Service Bulletin

Number: #02-07
 Date: 10/11/2001
 Subject: SEA RAY EXHAUST INSTALLATION/VERIFICATION & SALT WATER INTRUSION PROCEDURES FOR 310DA, 340DA, 370DA, 380DA, 400DA, 410DA, (1999 TO 2001 MODEL YEAR WITH COLLECTOR STYLE EXHAUST SYSTEMS)
 Recall/ Bulletin
 Service Bulletin:

SUBJECT: SEA RAY® EXHAUST INSTALLATION/VERIFICATION & SALT WATER INTRUSION PROCEDURES FOR 310DA, 340DA, 370DA, 380DA, 400DA, 410DA (1999 TO 2001 MODEL YEAR WITH COLLECTOR STYLE EXHAUST SYSTEMS)

Exhaust System Illustration:

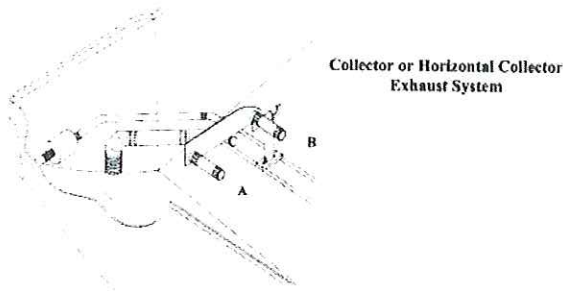
The system depicted above is representative of the type of system installed in Sea Ray® models for several model years. This system is often referenced as a *Collector or Horizontal Collector System*. Angles are extremely critical to this system. Note: All angles must be measured with a calibrated *Inclinometer* with the boat at static rest in the water.

Note: If you perform work in the bilge, or disassemble any of the exhaust components referenced above, it is your responsibility to ensure the angles are reestablished per the matrix 1A above. Failure to do so could result in an ingestion failure. If you need assistance, please contact either the Knoxville Customer Service Department at (800) 648-8535 or the Merritt Island Customer Service Department at (800) 648-2821.

1A	310DA			340DA			370DA			380DA			400DA			410DA		
	Angle Minimums In Degrees			Angle Minimums In Degrees			Angle Minimums In Degrees			Angle Minimums In Degrees			Angle Minimums In Degrees			Angle Minimums In Degrees		
	A	B	C	A	B	C	A	B	C	A	B	C	A	B	C	A	B	C
6.7L	7	7	0	7	7	0												
300Mag	7	7	0	7	7	0												
300Mag Horizon	7	7	0	7	7	0	NOT AVAILABLE											
MX 6.2L	7	7	0	7	7	0												
7.4L				7	7	0	7	7	0	7	7	0	7	7	0	7	7	0
454 Horizon				7	7	0	7	7	0	7	7	0	7	7	0	7	7	0

Water Lift Exhaust
System

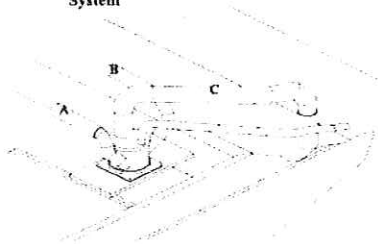
The system depicted above is a *Water Lift Style System*. This system is now utilized in all of Sea Ray's gasoline v-drive and inboard models. This system is also a system governed by angles. Note: All angles must be measured with a calibrated *Inclinometer* with the boat at static rest in the water.

Note: If you perform work in the bilge, or disassemble any of the exhaust components referenced above, it is your responsibility to ensure the angles are reestablished per the matrix 1B above. Failure to do so could result in an ingestion failure. Again, please call either Merritt Island or Knoxville Customer Service if you need assistance.

1B	310DA			340DA			380DA			400DA			410DA		
	Angle Minimums In Degrees			Angle Minimums In Degrees			Angle Minimums In Degrees			Angle Minimums In Degrees			Angle Minimums In Degrees		
	A	B	C	A	B	C	A	B	C	A	B	C	A	B	C
300Mag	7	7	7	7	7	7									
300Mag Horizon	7	7	7	7	7	7	NOT AVAILABLE								
MX 6.2L	7	7	7	7	7	7									
454 Horizon				7	7	7	7	7	7	7	7	7	7	7	7
8.1L				14	14	7	14	14	7	14	14	7	14	14	7
